ST EDMUNDSBURY DEVELOPMENT CONTROL COMMITTEE - THURSDAY 28 MARCH 2019

Development Control Committee 28 March 2019

Additional Supplement

Item 4 – DC/18/0382/FUL: Cornhill Walk, Brentgovel Street, Bury St. Edmunds

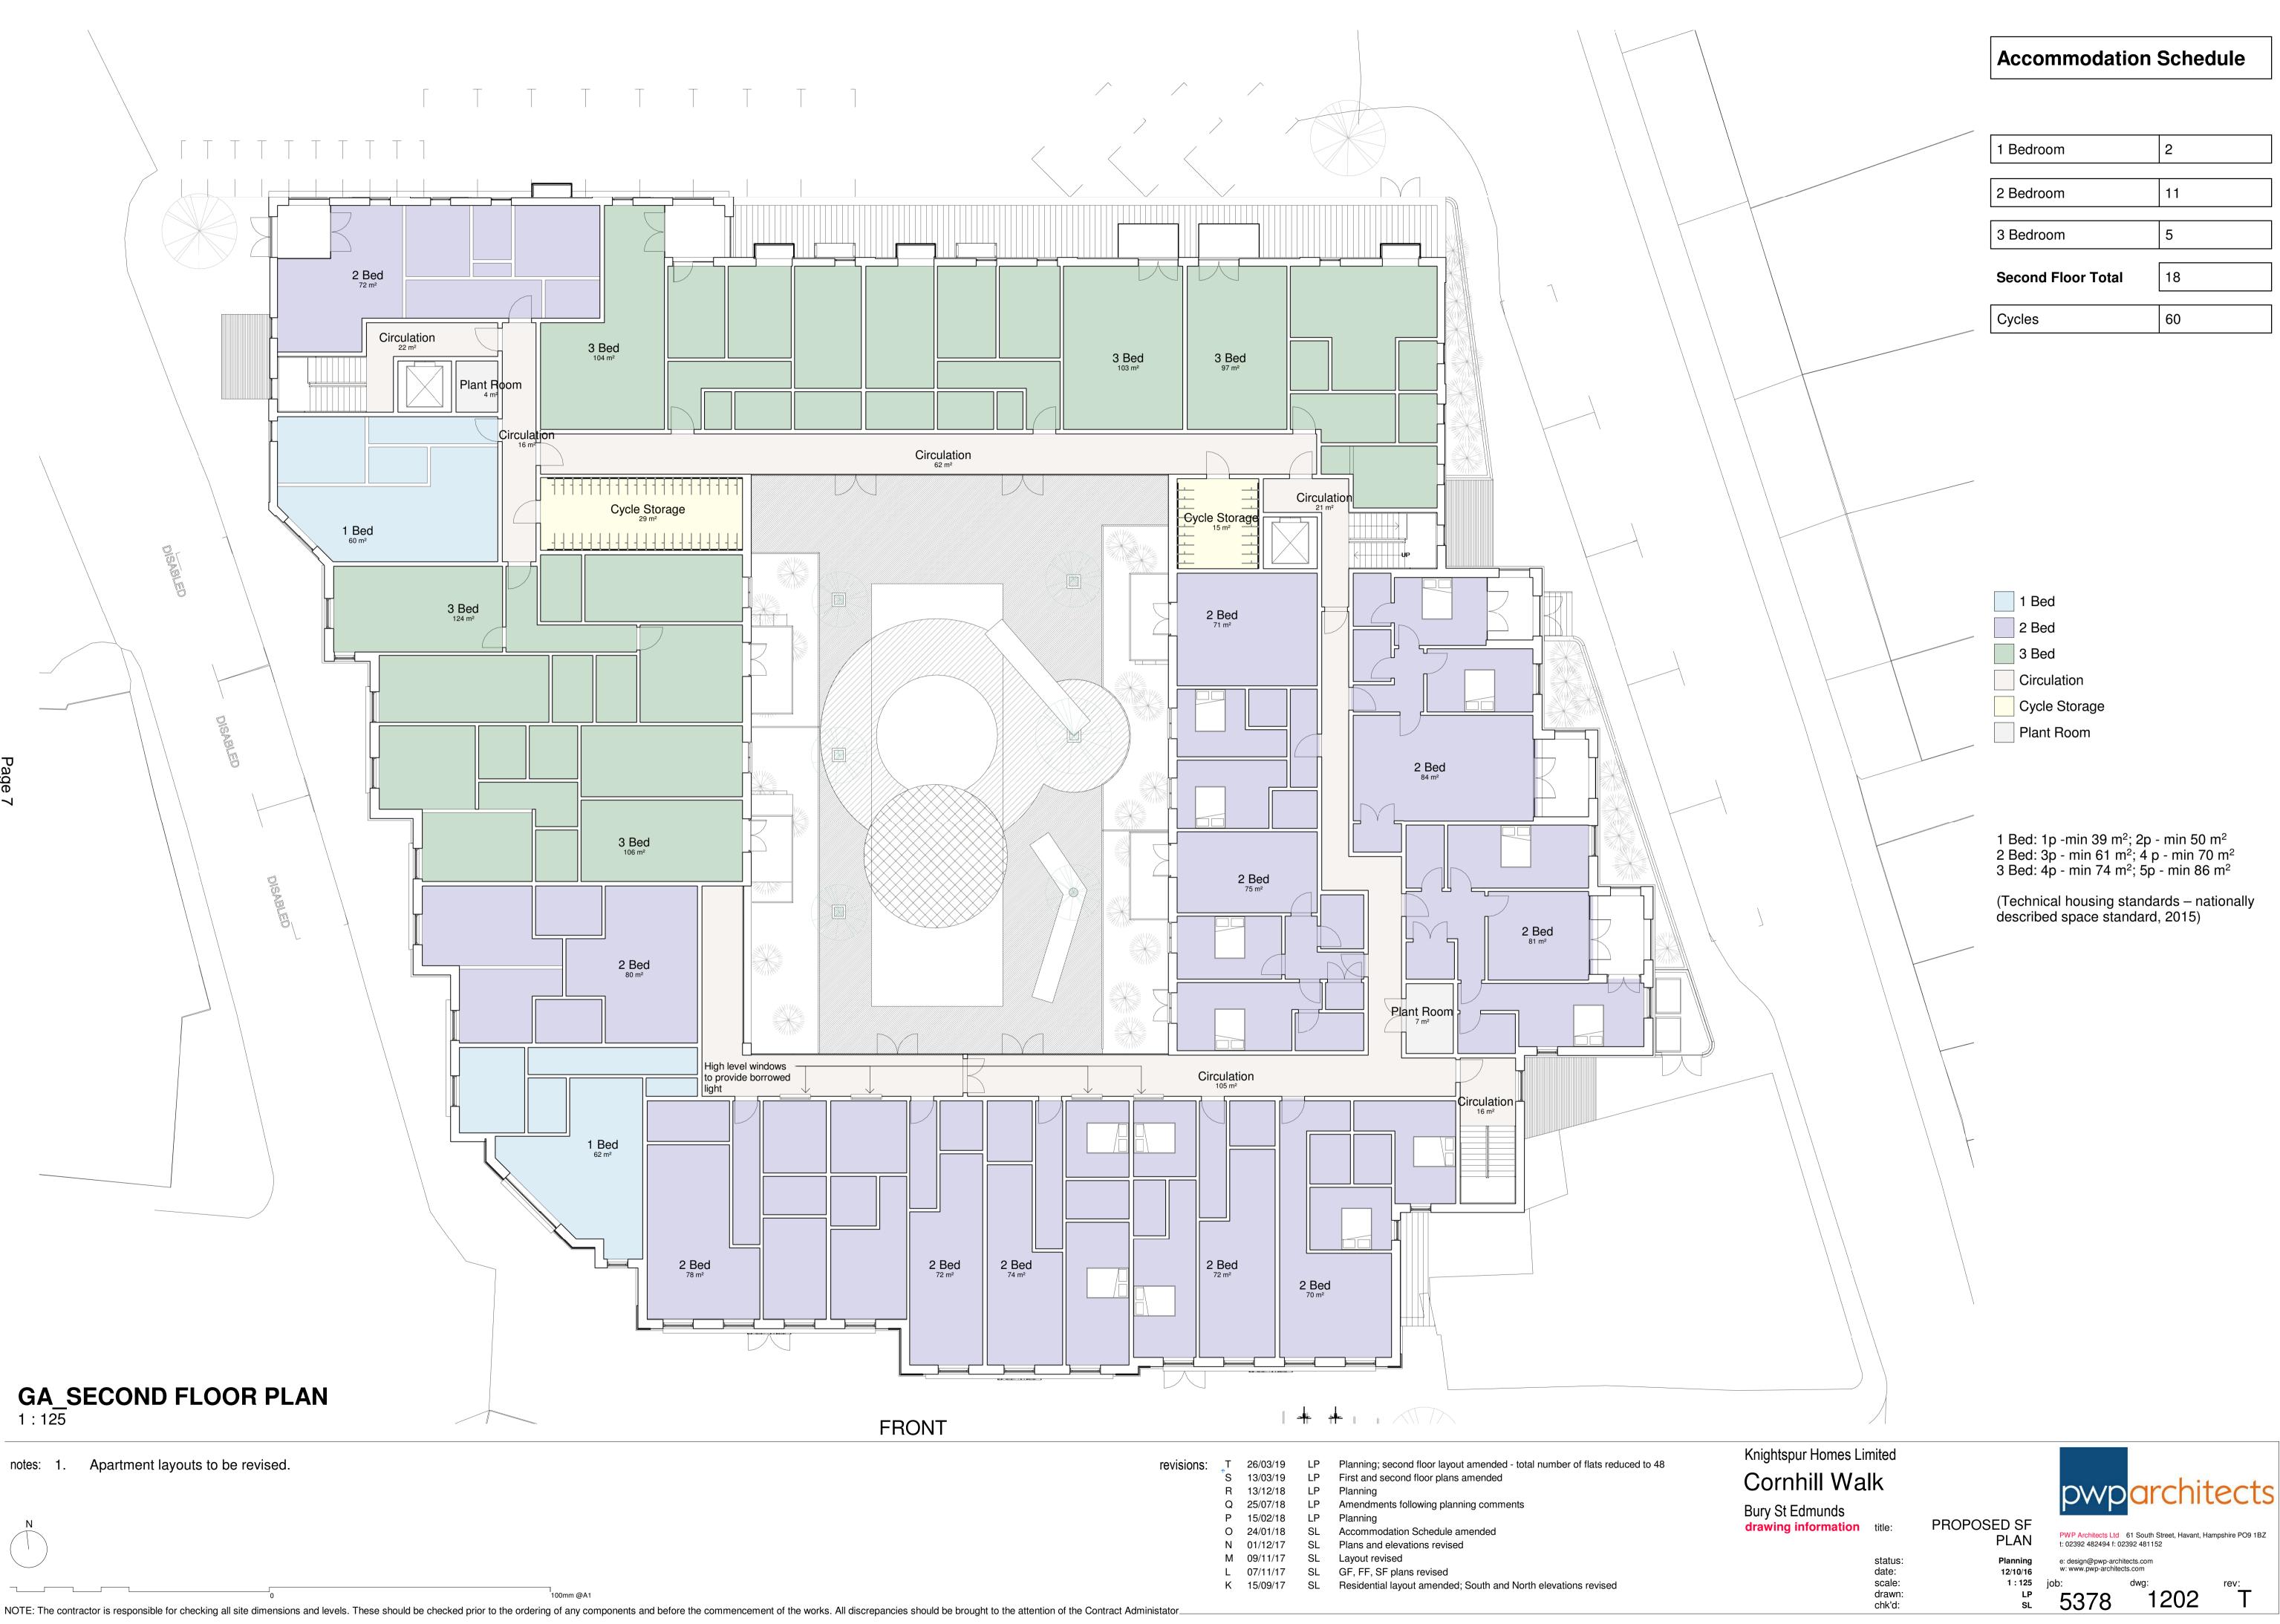
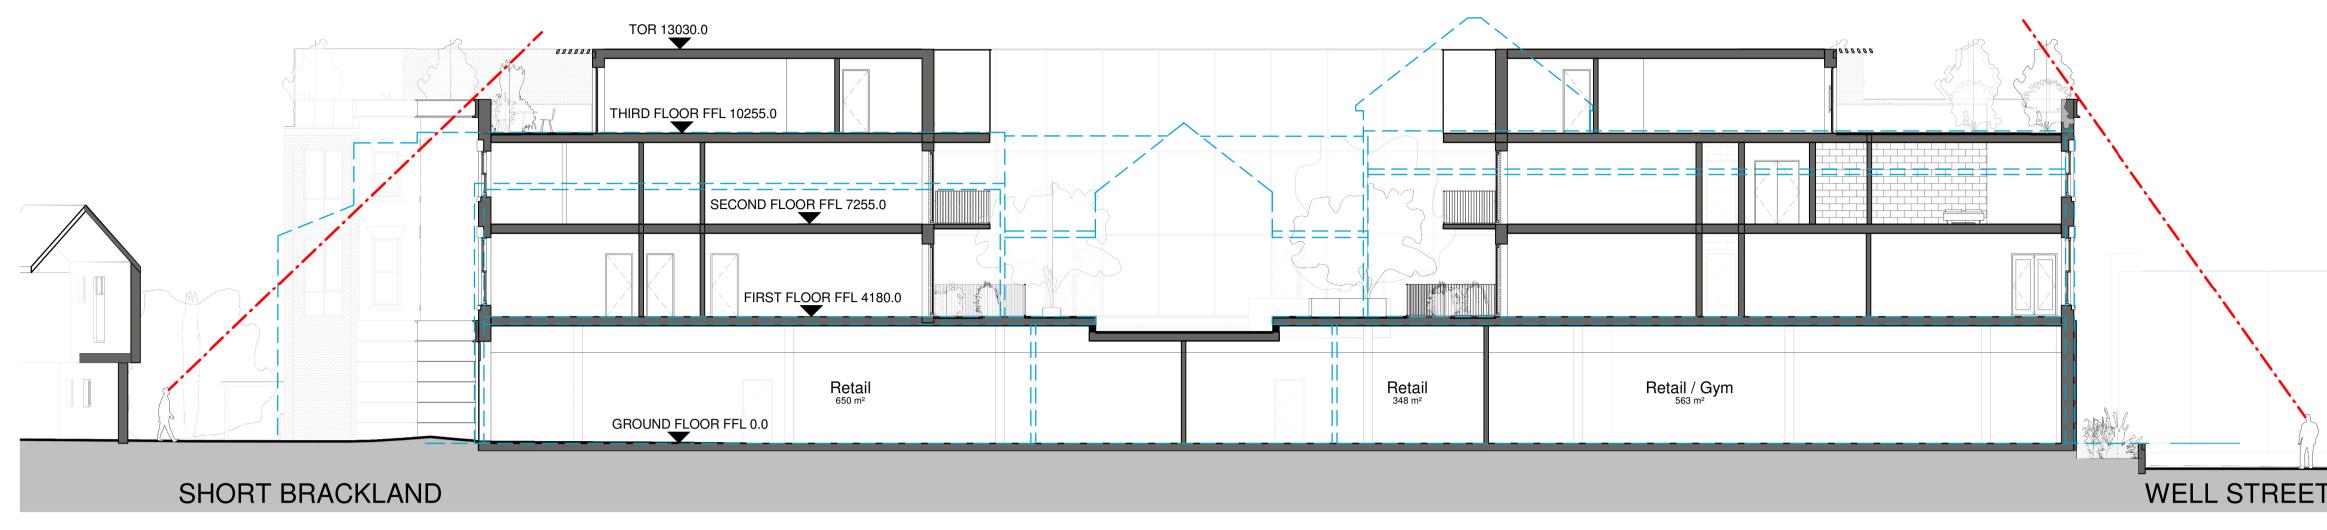
The attached amended plans show a reduction in residential units from 49 to 48. This means that every apartment has access to a lift and cycle storage on each floor.

In addition, the parking space adjacent to No. 8 Well Street has been removed and replaced with cycle parking to serve the commercial units. Further cycle parking for these commercial units is provided to the front of the site.

revisions	: LL	26/03/19	LP	Planning; second floor layout amended - total number of flats reduced to 48
	KK	15/03/19	LP	Retail bicycle parking added, car sharing spaces omitted
	JJ	13/12/18	LP	Planning
	П	25/07/18	LP	Amendments following planning comments
	HH	23/02/18	LP	Planning
	GG	15/02/18	LP	Planning
	FF	09/02/18	SL	Refuse and recycling amended
	EE	01/12/17	SL	Plans and elevations revised
	DD	09/11/17	SL	Layout revised
	CC	08/11/17	SL	Layout revised

PROPOSED SECTION 1 1 : 125

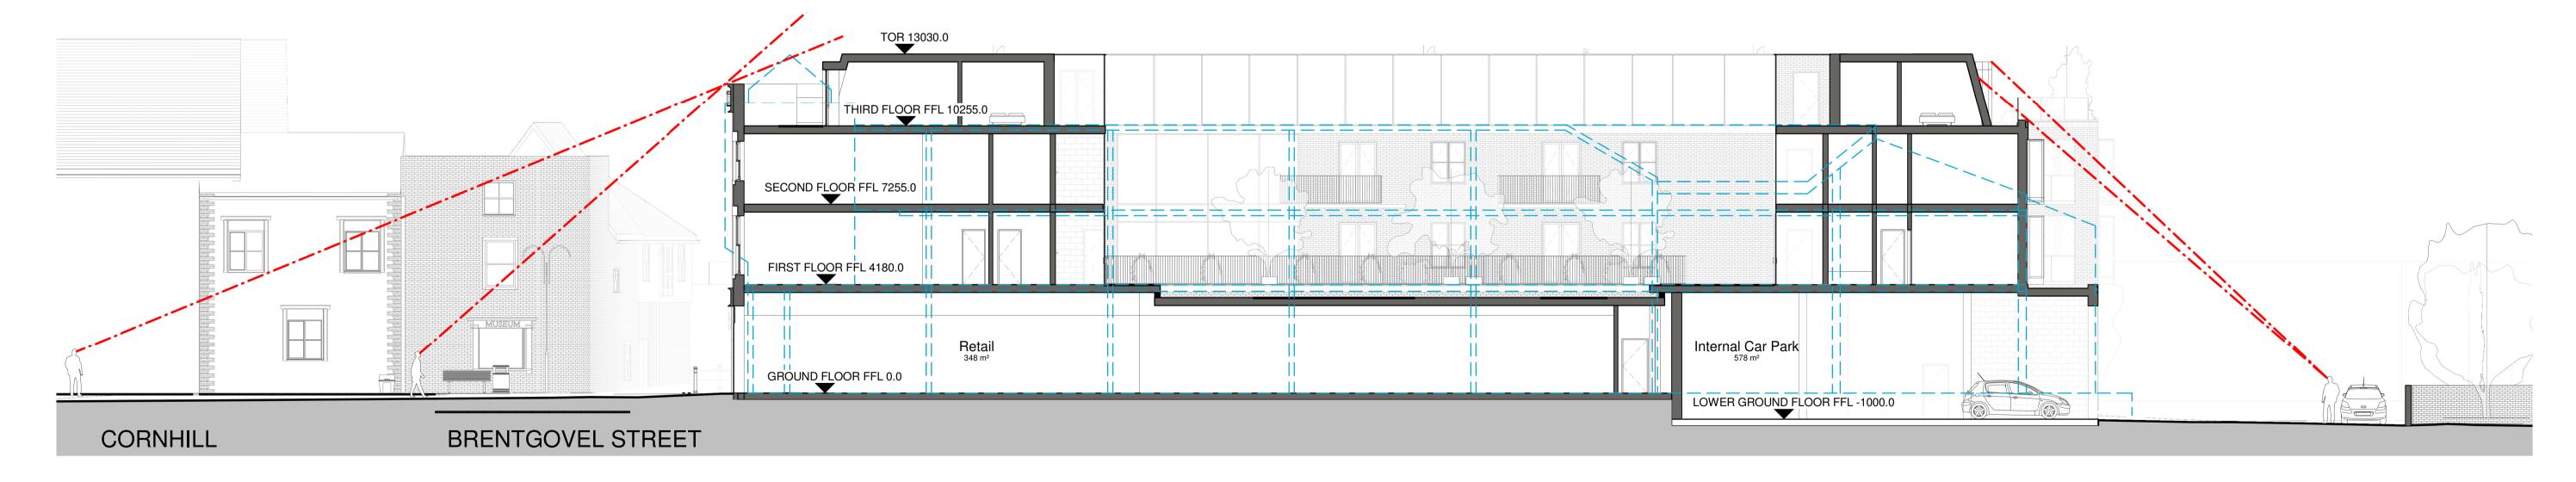
revisions:	D	26/03/19	LP	Planning; second floor layout amended - total number of flats reduced to 48
	С	18/03/19	LP	Planning - sight lines added
	В	13/12/18	LP	Planning
	Α	15/02/18	LP	Planning
